## Staff Report to the Plan Commission – Revised

Valvoline Instant Oil Change

**Project:** 2025-0321 – Valvoline Instant Oil Change – 179<sup>th</sup> & Wolf Road**Planner:** Rob Fischer**Petitioner/Representative:** Dan Elliott**Location:** 11320 179<sup>th</sup> Street**P.I.N.s:** 27-31-202-019-0000**Parcel Size:** 82,915.15 SF (23,790 SF project area)

## **PRELIMINARY LANDSCAPE PLAN**

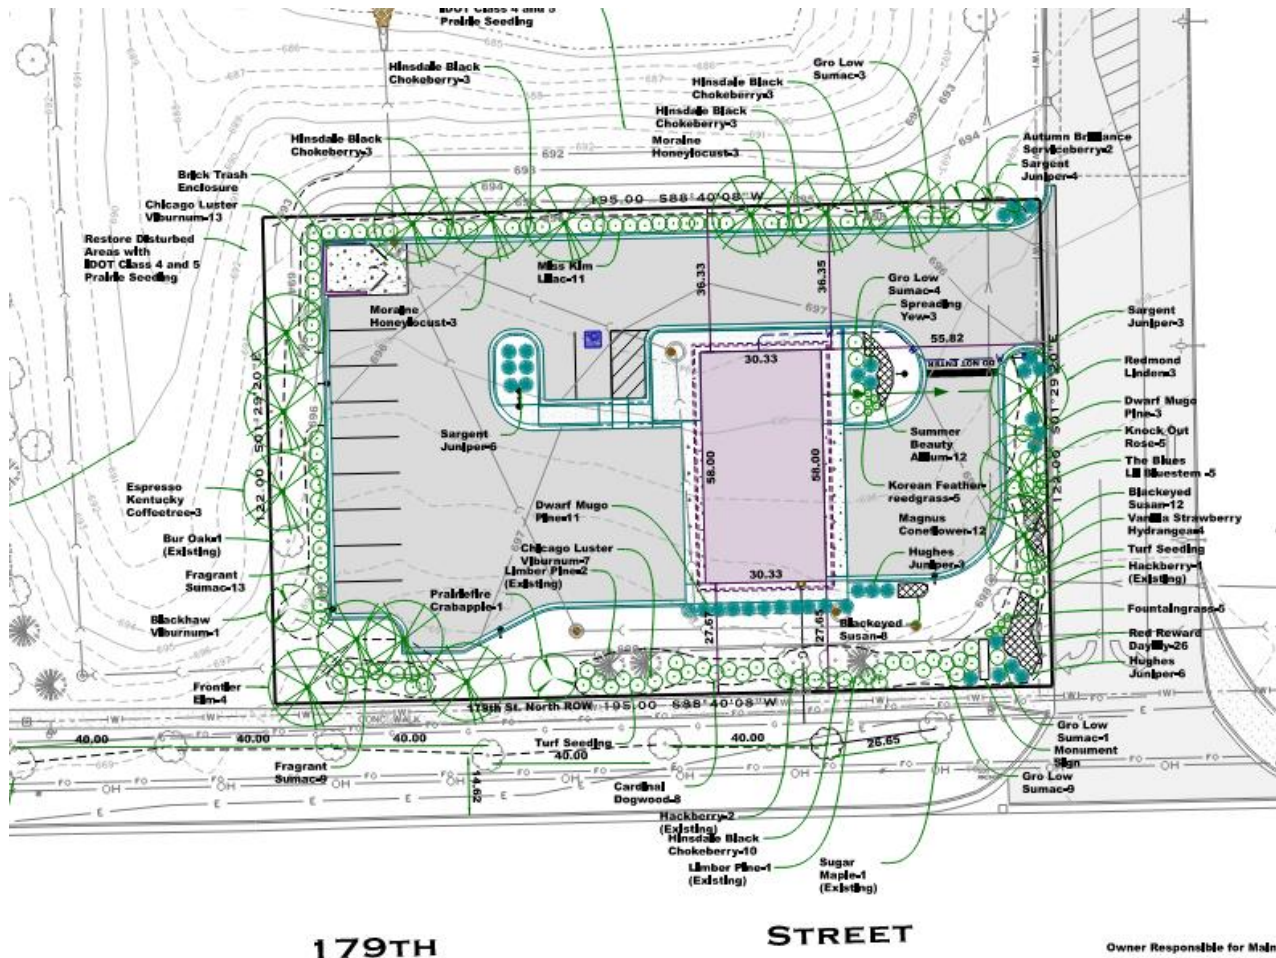
The preliminary landscape plans are compliant with the Land Development Code apart from the required maintenance access path for the Lot 1 detention basin, for which the petitioner is seeking a variance. LDC Section 6-305.D.8.b.4 calls for a maintenance vehicle access area (which) shall be provided around the pond, at least 8' wide not exceeding a 2% cross slope and shall remain open and accessible for maintenance purposes, planted with native low-growing plant materials or as a recreational/maintenance trail.

Per LDC Section 5-109, the petitioner has provided responses to standards applicable to all variances. Any outstanding comments must be completed during the final landscape review. The representative plant list appears to meet diversity requirements for number of species, and the percentage of species will be evaluated during the final landscape plan review. The petitioner states meeting the requirement is cost prohibitive and that maintenance staging may utilize the Valvoline site.
